Town of Hilton Head Island
Design Review Board Meeting
Tuesday, February 9, 2021 – 1:15 p.m.
AGENDA

i. St. Andrews Church Entry, DRB-000097-2021

PROJECT NAME: St. Andrew's Entry

St Andrews by the Sea

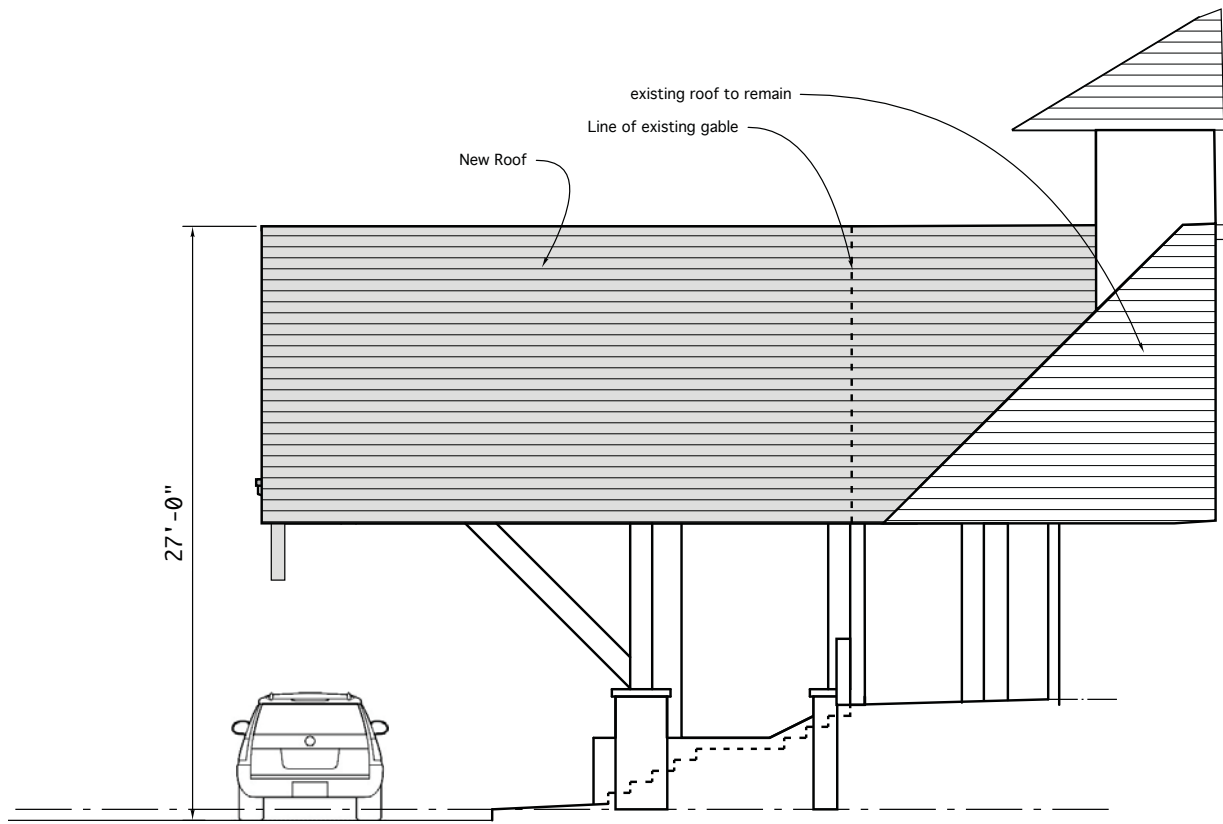
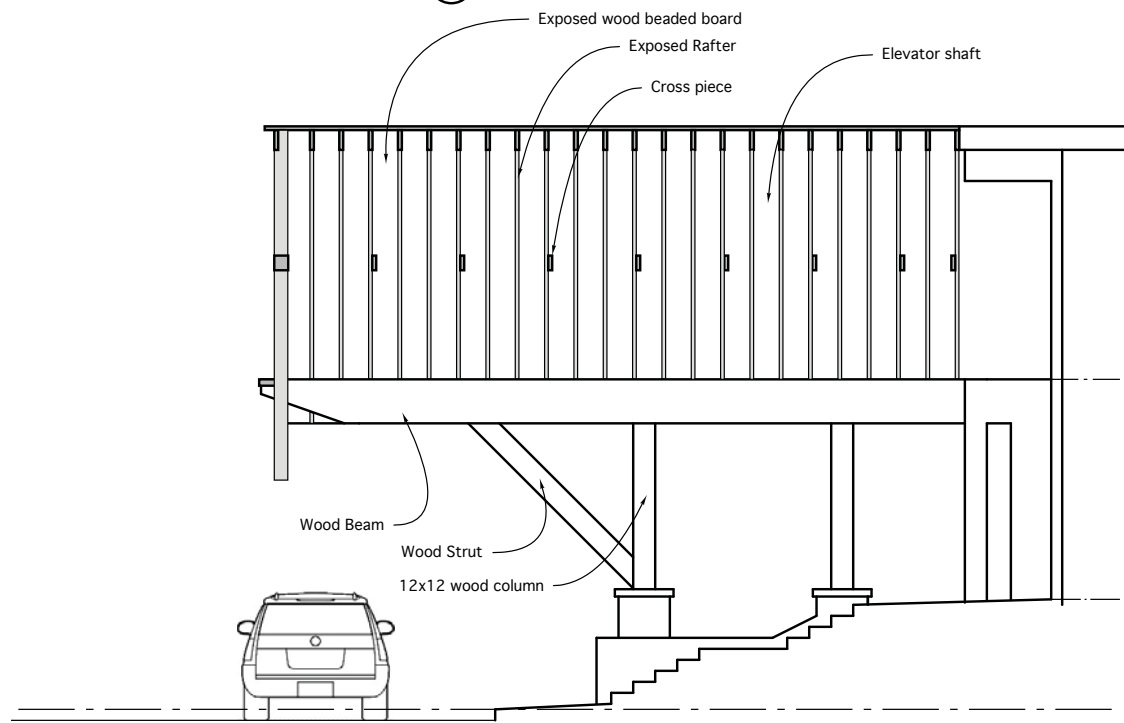
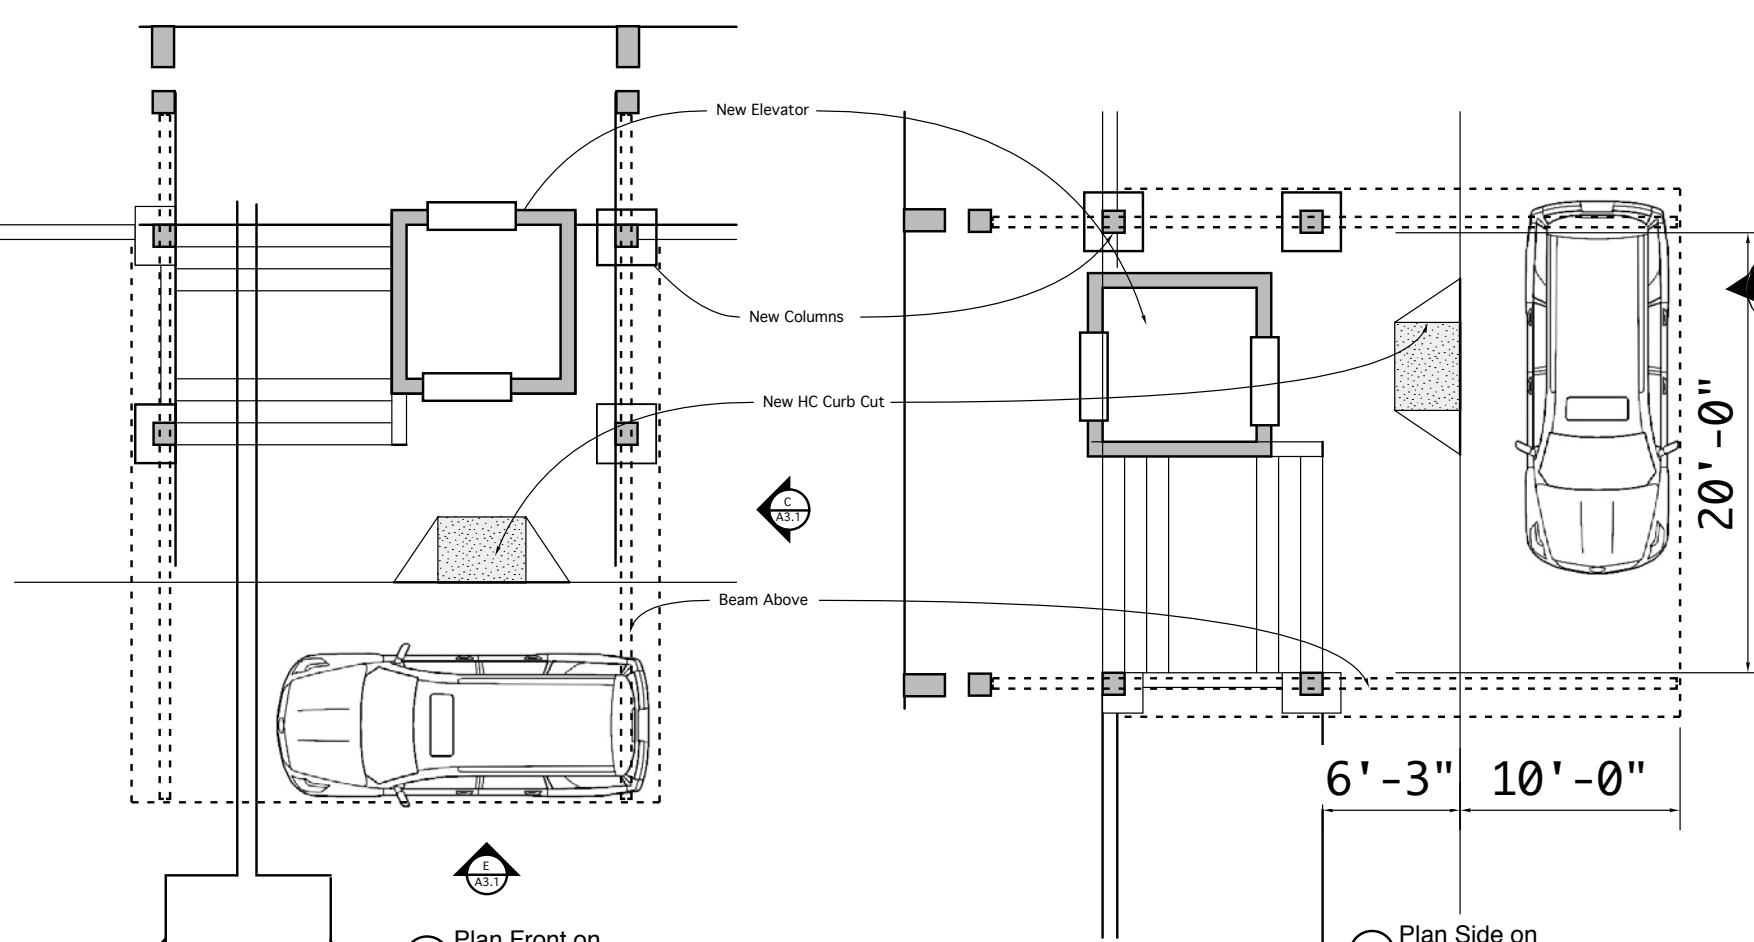
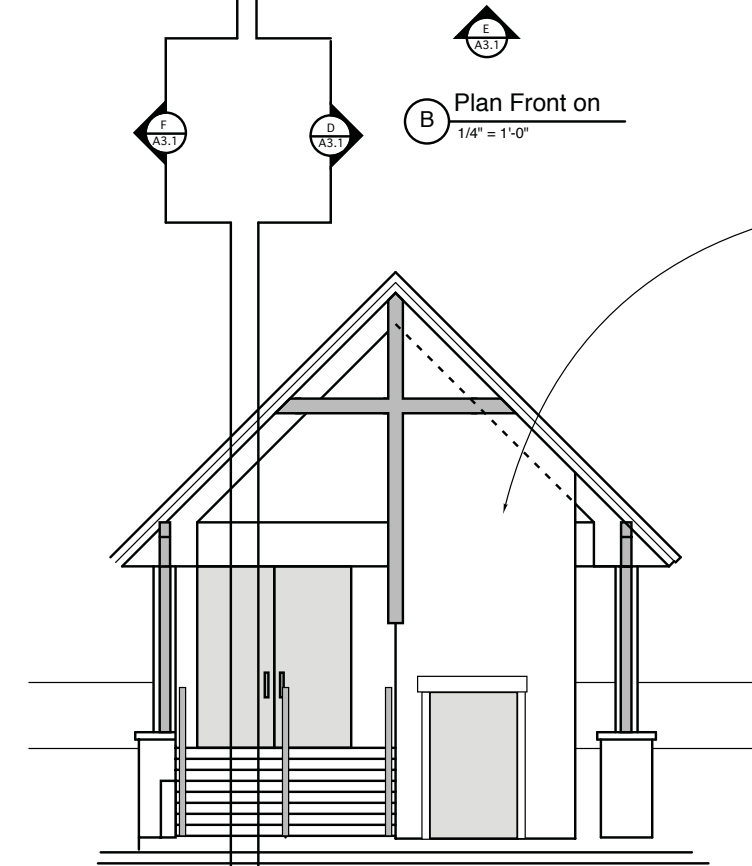
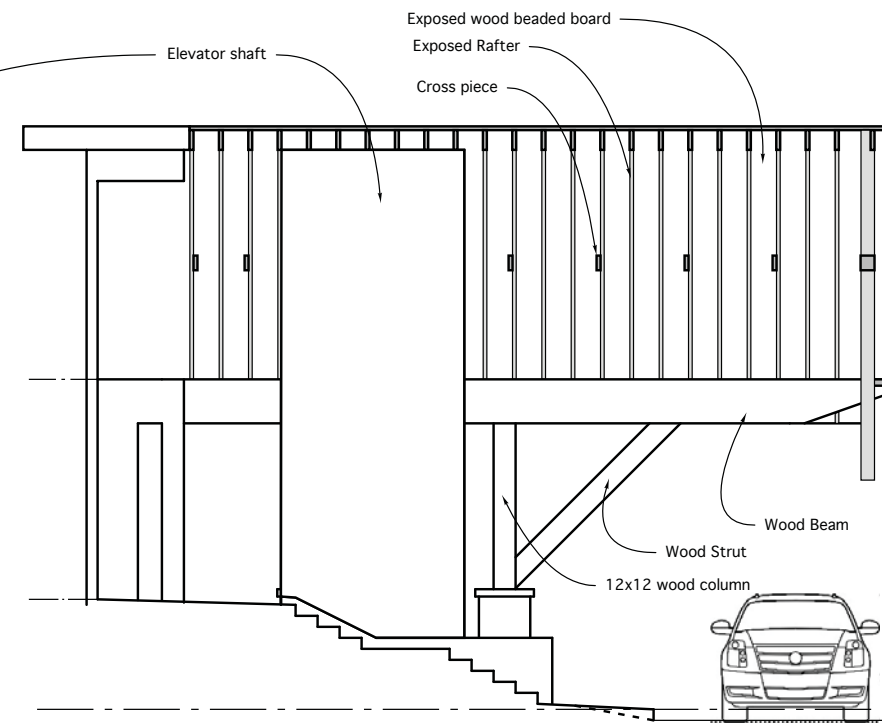
APPLICATION MATERIAL				
DRB REQUIREMENTS	Complies Yes	No	Not Applicable	Comments or Conditions
Dimensioned Details and of Sections	<input type="checkbox"/>	<input checked="" type="checkbox"/>	<input type="checkbox"/>	The provided sections and details lack specifics: 1. wood column connection details and finish, 2. new roof material, color and finish, 3. dimensions 4. treatment of existing door and windows.
Detail Illustrating Connection to Existing Structure	<input type="checkbox"/>	<input checked="" type="checkbox"/>	<input type="checkbox"/>	The connection is not clear in the provided plans.
New Building Details Match Existing Building Details	<input type="checkbox"/>	<input checked="" type="checkbox"/>	<input type="checkbox"/>	Not specified.

This is an Alteration / Addition and as such only requires one review by the DRB. It is Staff opinion that not enough detail and specification of materials and colors is provided in the drawings for DRB approval. Staff is not opposed to the concept but the number of missing specifications in the drawings requires the recommendation of "Denial".

DATE: 07-18-2019
PROJECT NUMBER: 01-18056
SHEET TITLE: Site Plan

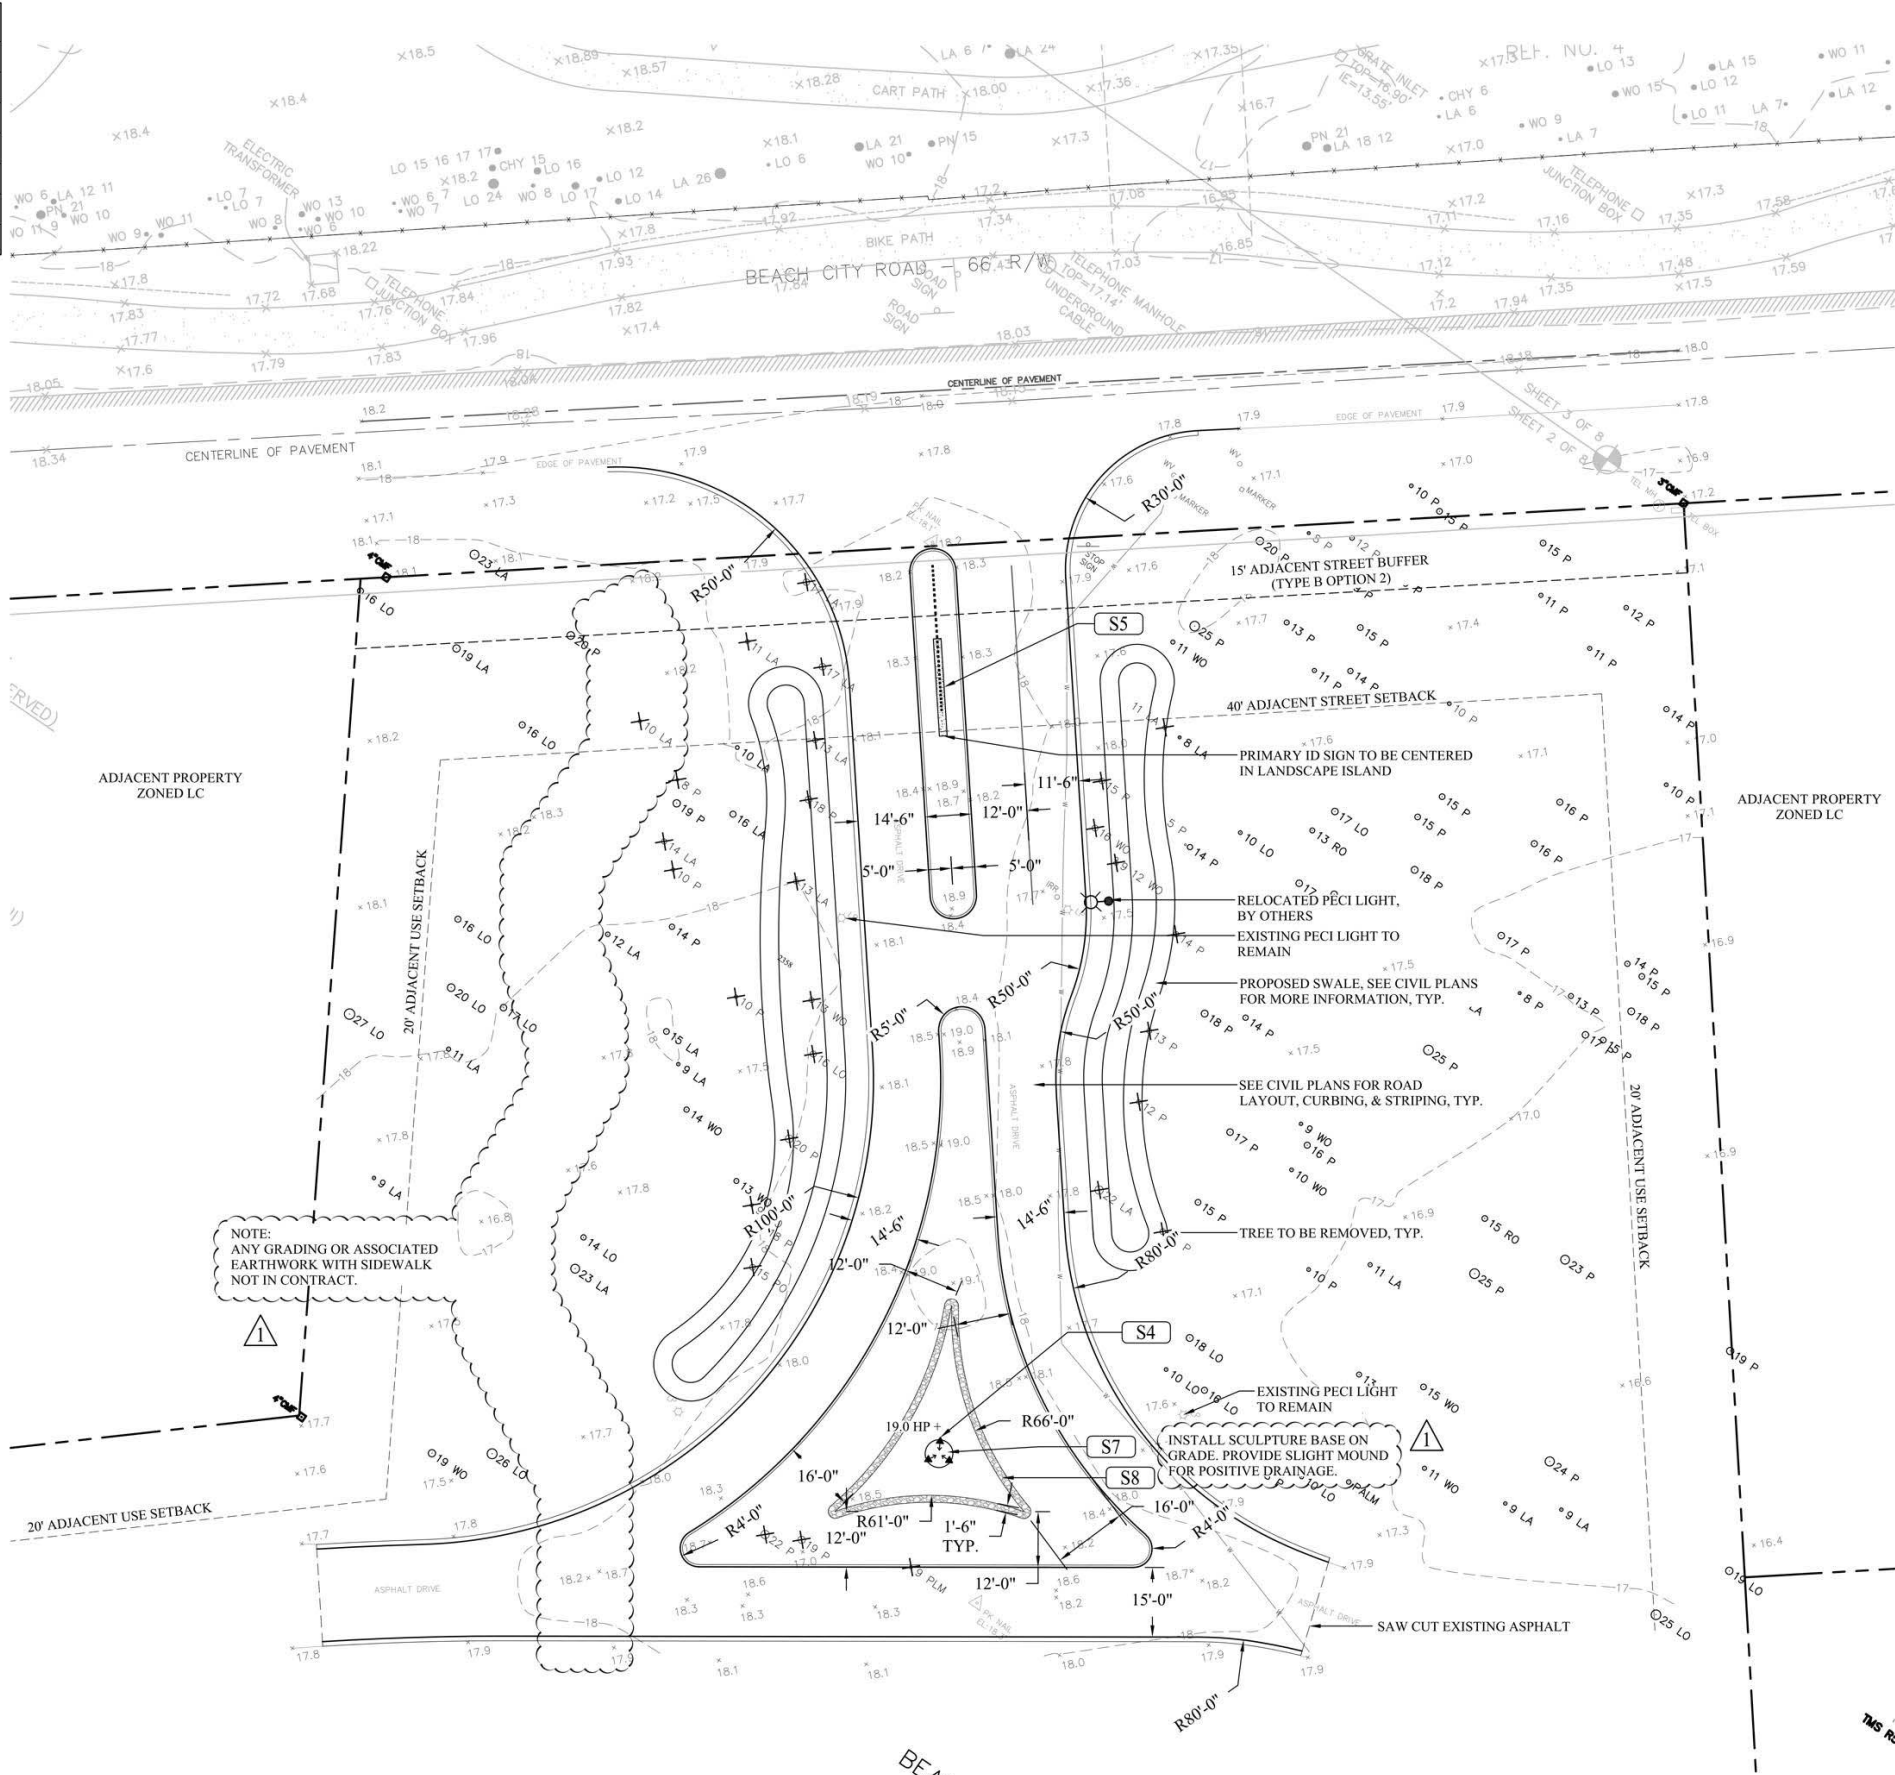
- L-100 Site Plan:
 - Remove concrete sidewalk along western side of entrance (and all grading & earthwork associated with sidewalk)
 - Remove all pathway bollard lights
 - Remove paver crosswalk
 - Remove metal retaining wall & associated fill. Sculpture base to be installed on grade; provide small mound for drainage (see spot grade on plan)
- L-200 Details:
 - Pathway accent light removed from project
 - Revised monument sign detail (sign wall now 3 part stucco with oyster shell finish; changed 8" CMU blocks to 12" CMU blocks)
- L-201 Details:
 - Removed retaining wall from project
 - Removed pavers from project
 - Removed concrete walk from project
- L-300 Planting Plan:
 - Removed note calling for seeding in brush hogged area

1. An application for this sign was approved at the May 14, 2019 DRB meeting.
2. The sign was installed minus elements of the approved plan. The applicant was given the option of installation of those elements as part of the terminal renovations or request DRB approval as constructed.
3. It appears more area was cleared than necessary for the entrance road modifications minus other elements of the approval.
4. Per the Design Guide, page 27 "their (freestanding or monument signs) design must complement the architectural design of the building(s) and other elements of development on the site." Without the other approved elements (i.e., the metal retaining wall) what does this sign relate to on the site?
5. Staff will not recommend substantial alteration of a DRB approval.
